**Telecommunications and exchange  
between information technology  
systems — Requirements for local and  
metropolitan area networks —**

**Part 3:  
Standard for Ethernet**

**AMENDMENT 5: Physical layers  
specifications and management  
parameters for 10 Mb/s operation and  
associated power delivery over a single  
balanced pair of conductors**

Reference number  
ISO/IEC/IEEE 8802-3:2021/Amd.5:2021(E)

##### 30.2.2.1 Text description of managed objects

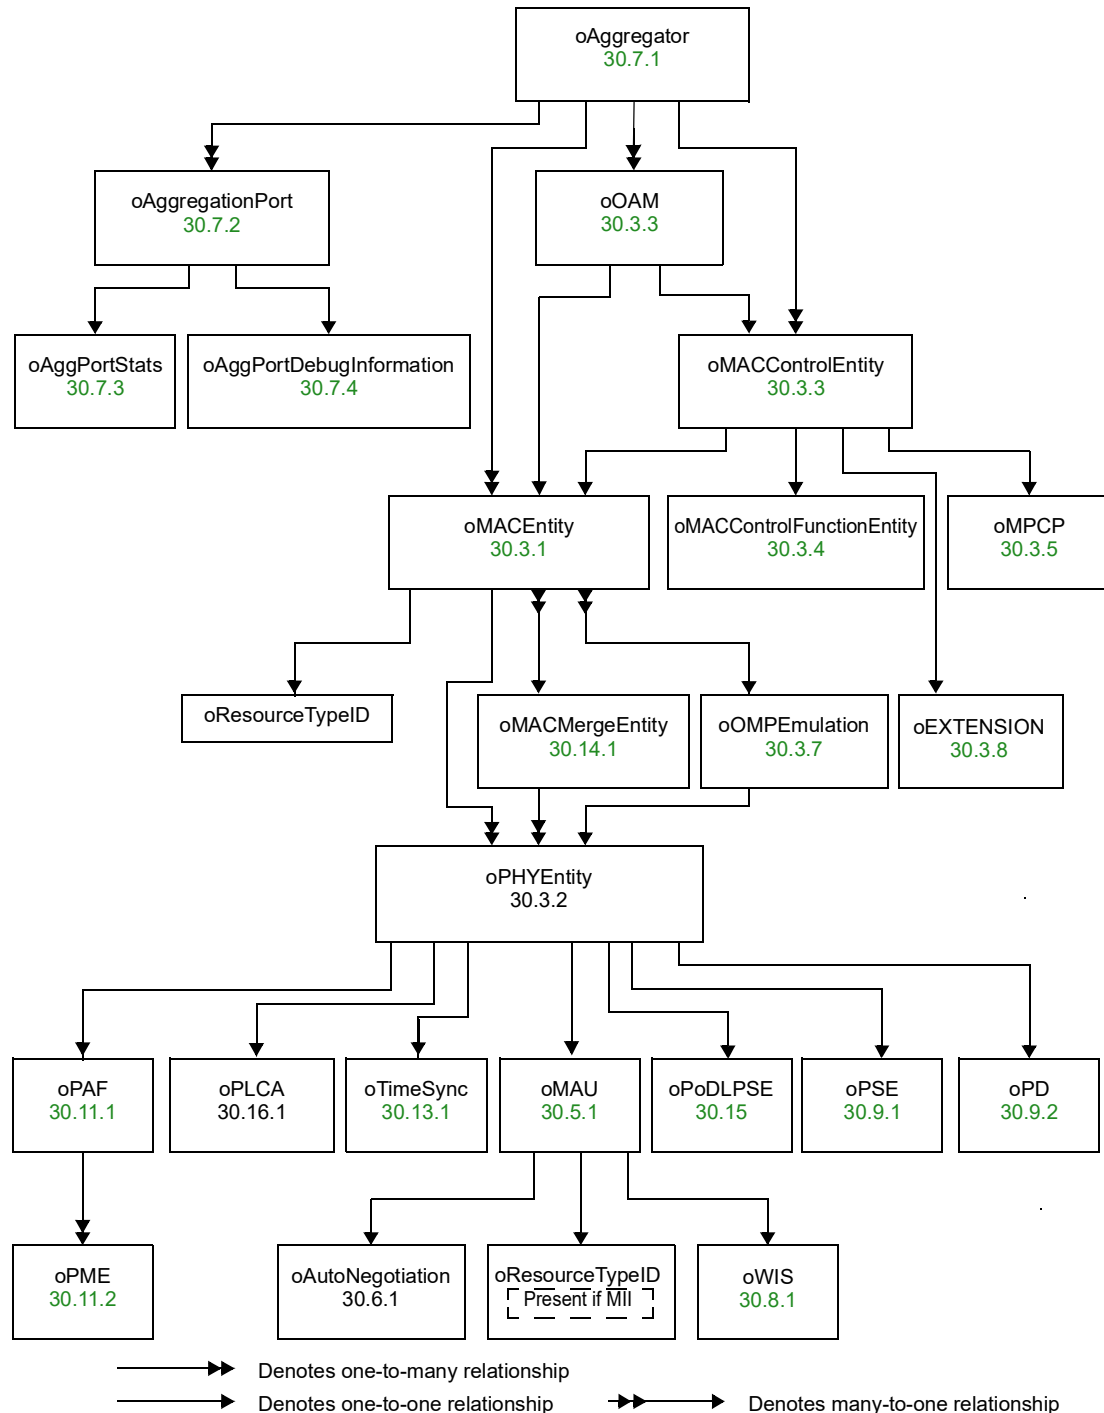
*Change the description for oPHYEntity in 30.2.2.1 as follows:*

| <b>oPHYEntity</b> | If oOMPEmulation is implemented, oPHYEntity is contained within oOMPEmulation. If oMACMergeEntity is implemented, oPHYEntity is contained within oMACMergeEntity. Otherwise oPHYEntity is contained within oMACEntity. Many instances of oPHYEntity may coexist within one instance of oMACEntity or oMACMergeEntity; however, only one PHY may be active for data transfer to and from the MAC at any one time. oPHYEntity is the managed object that contains the MAU, PAF, <u>PLCA</u> , PSE, and PoDLPSE managed objects in a DTE. |
